BELCO PETROLEUM CORPORATION OF PERU

MEMORANDUM

A:	GEOLOGY MANAGER	Fecha January 8th, 1985
DE:	CHIEF RESERVOTR ENGINEER	Asunto WELL LO6-5

A: Geology Manager	Fecha January 3rd, 1984
DE: Mario Chávez	Asunto GEOLOGICAL COMMENTS FOR WELL
	L06-5

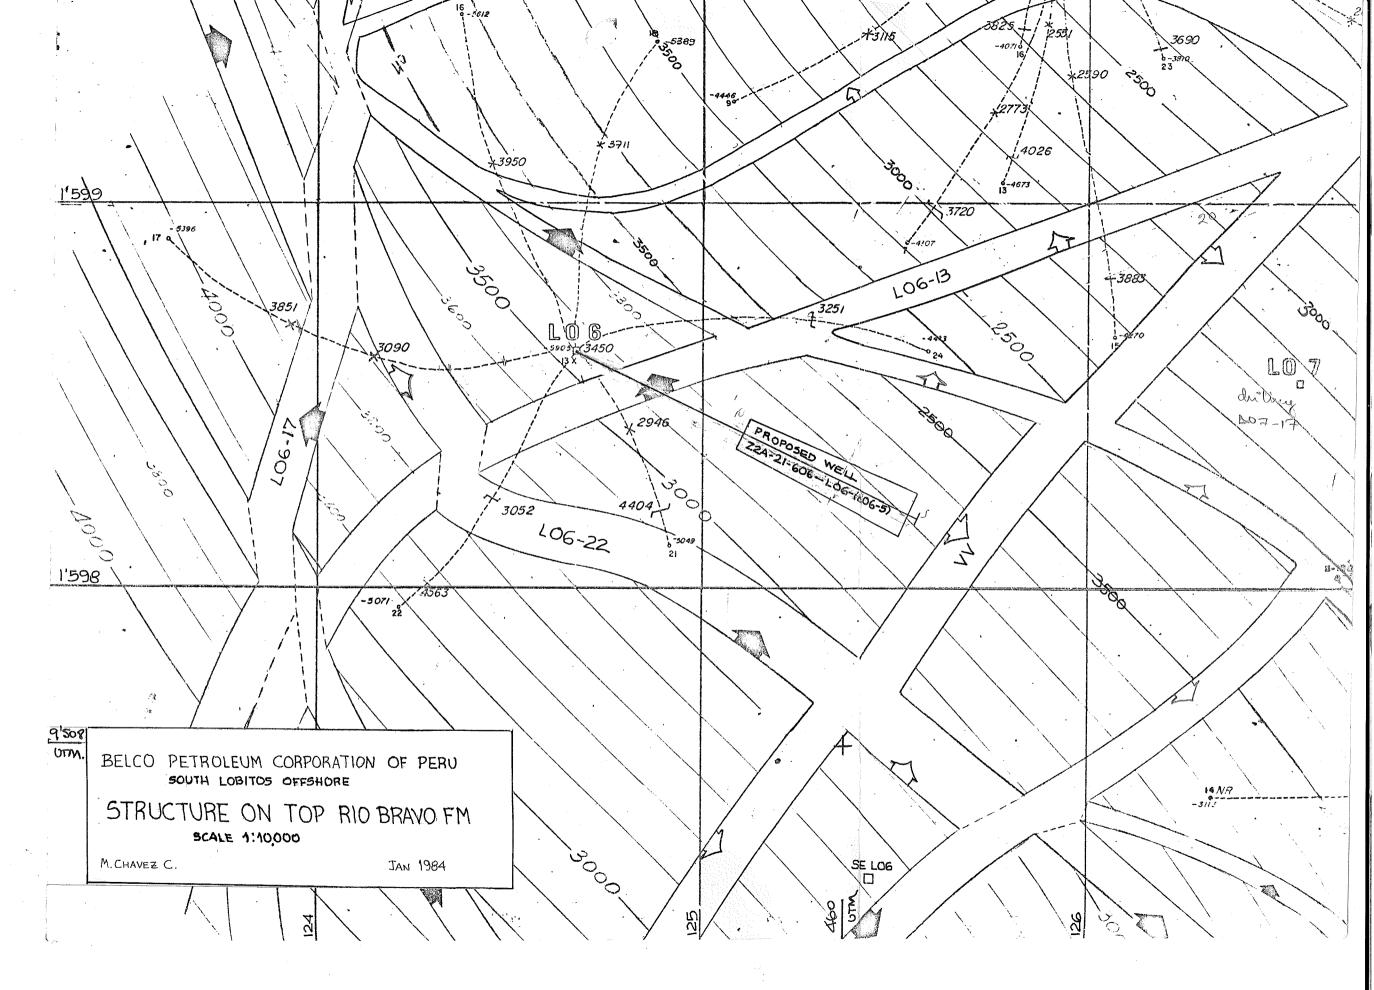
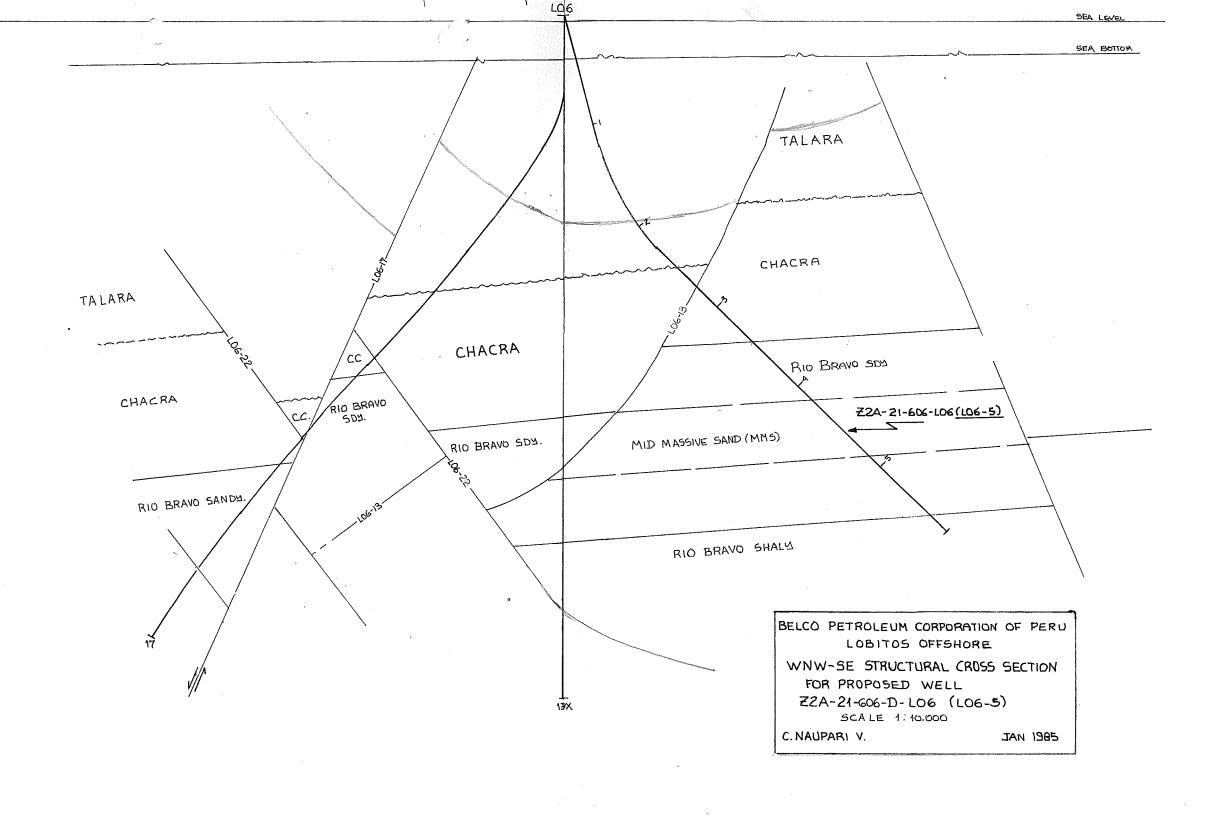
This is a normal spacing well offsetting L06-24, which has a well developed sandy Rio Bravo section that may have faulted in L06-21 (the other well being offset by this well), explaining the difference in production performance.

Target size and logging program comply with the guidelines.

Reservoir concurs with the proposed location.
